TITLE: MI Peaks TH PWM Sandwich version		REV: 1.0
EasyEDA	Company: Your Company	Sheet: 1/1
	Date: 2021-07-01	Drawn By: Kristian Blå sol

TITLE: Sheet_2		REV: 1.0
EasyEDA	Company: Your Company	Sheet: 1/1
	Date: 2021-10-19	Drawn By: Kristian Blå sol

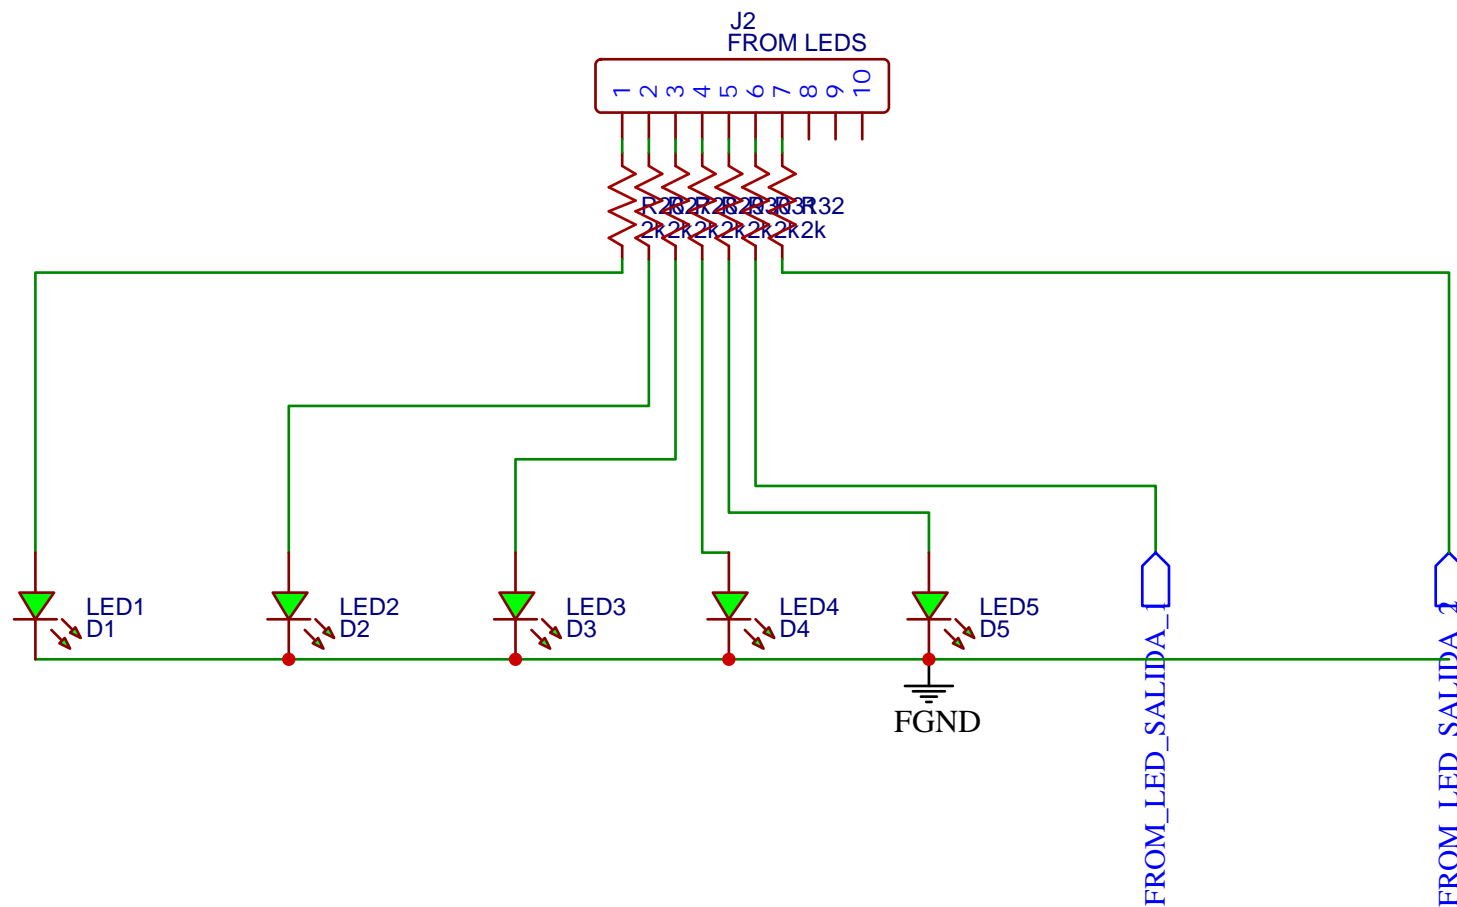
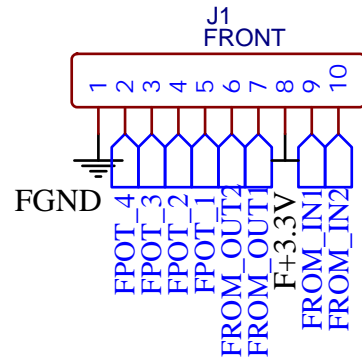
V0.2

- Turned all Pots around.
- Changed all buttons which were ALL wrong.
- Bigger mode and split buttons.
- Added a stud to keep front panel in place when pushing split and mode with alps pots. C130896 stud

V0.3

- Mode and split was still wrong. Changed place. DONE!
- Output 2 isnt working? U2.2 wrong orientation. DONE!
- TRIG LEDs not working wrong orientation? DONE!

Ändrat C10 fr 033 till 10u
